Product Change Notification: PCN-21-105944

PCN Date: 25-JUN-21

DEUTSCH DT 8 and 12 Position Plug and Receptacle C and D Key Temporary Color Change

Example of Cap on D Key Receptacle

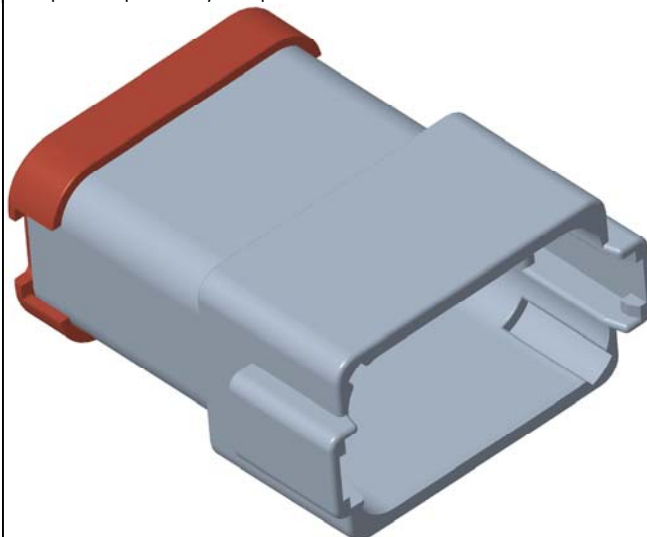
The Industrial and Commercial Transportation business unit of TE Connectivity is making a temporary (six months maximum) change to the color of the part numbers listed below. Instead of green or brown, the parts will be gray. For connectors without an end cap, a colored dot will be added to the connector to designate it as a C key (green dot) or a D key (brown dot). For connectors with an end cap, the end cap color will designate the key, green for C key and brown for D key. A corresponding colored dot will be added to the label on the box and a corresponding colored sheet of paper with a note will be added inside the box. With global demand in excess of supply on PA66, the material supplier is restricting TE's buying allotment on certain colors. These PNs are TE proprietary designs, therefore considered catalog/general market product. Product drawing(s) are not affected.
